Technical Service Bulletin

Date: 2014-07-01

Subject:	TSB-CP150 V2.00.02 SOFTWARE RELEASE
Distribution Scope:	Welch Allyn Global Technical Support, Product, Field & Customer Service teams and WA ASP's
Product(s) Referenced:	All CP150 Electrocardiographs <ul style="list-style-type: none"> • CP150-0029 / SERV KIT, SOFTWARE (ONLY) UPDATE v2.00.02 • CP150-0017 / SERV KIT, SOFTWARE UPDATE v2.00.02 • CP150-0004 / SERV KIT, SMCE PCA • CP150-0004A / SERV KIT, SMCE PCA w INTERP • 20013803 TSB-CP150 V1.00.03 SOFTWARE RELEASE
SW Version:	All software versions prior to v2.00.02
Summary:	<p>The Welch Allyn Diagnostic Cardiology Team is pleased to announce an updated version of software for the CP150 electrocardiographs. This version 2.00.02 software was developed to enhance the functionality and performance of the CP150 electrocardiograph as outlined below.</p> <p>v2.00.02 Manufacturing starting serial number: 100012672614</p> <p><u>NOTE:</u> This software update is not applicable for Singapore and China CP150 units until registration of version 2.00.02 is complete. This TSB will be updated as China and Singapore complete registration.</p> <p>For China and Singapore customers, refer to: 200138

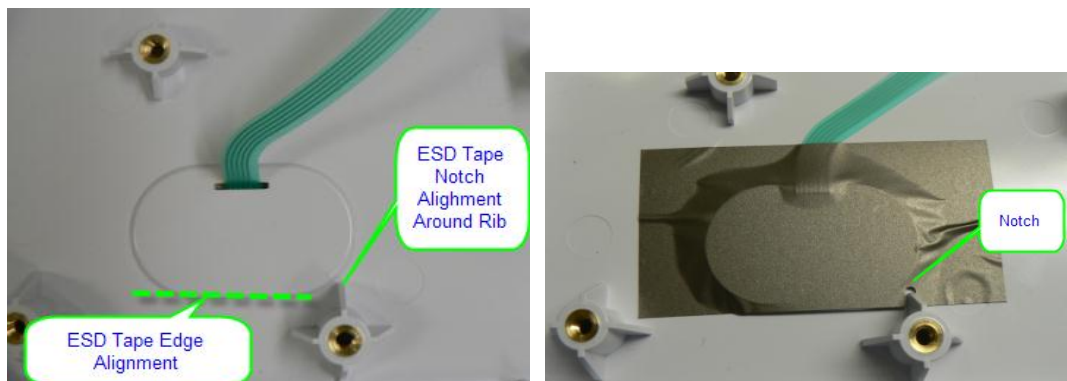
B) Replace the hardware components:

- I. Remove Top Housing assembly from the unit.
- II. Using tweezers, carefully peel the Power Switch Membrane from the Top Housing and remove the Flex cable.

- III. Insert the new Flex cable through the slit in the Top Housing. Remove the adhesive liner from the Power Switch Membrane. Make sure that the liner next to the flex is also removed. Press and secure the Switch Membrane into the recessed area.

- IV. Affix ESD Tape over the underside of the Power Switch and the protruding flex circuit. Align the notch on the screw post rib as shown. Align the edge of the tape around the edge of the indentation for the Power Switch as shown.

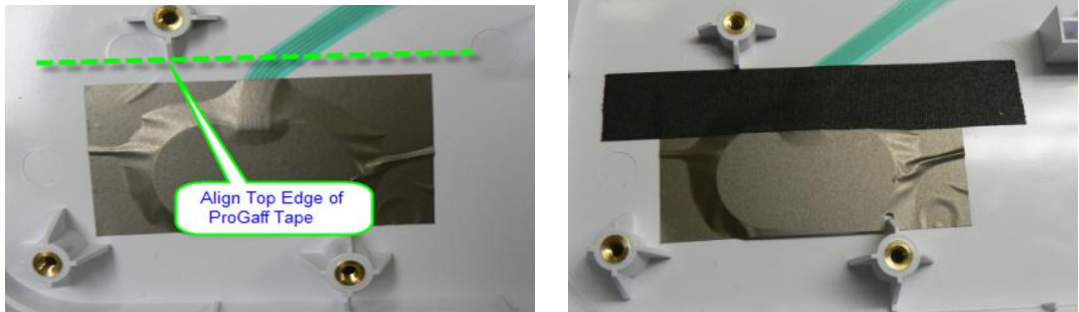
V. Add Pro Gaff tape over the EMC Tape. The Pro Gaff Tape should overlap over the length of the ESD Tape. The Pro Gaff Tape top edge should be aligned just under the screw post rib as shown.

- Reassemble back the Top Housing assembly to the unit. Perform all necessary tests and functional checks.
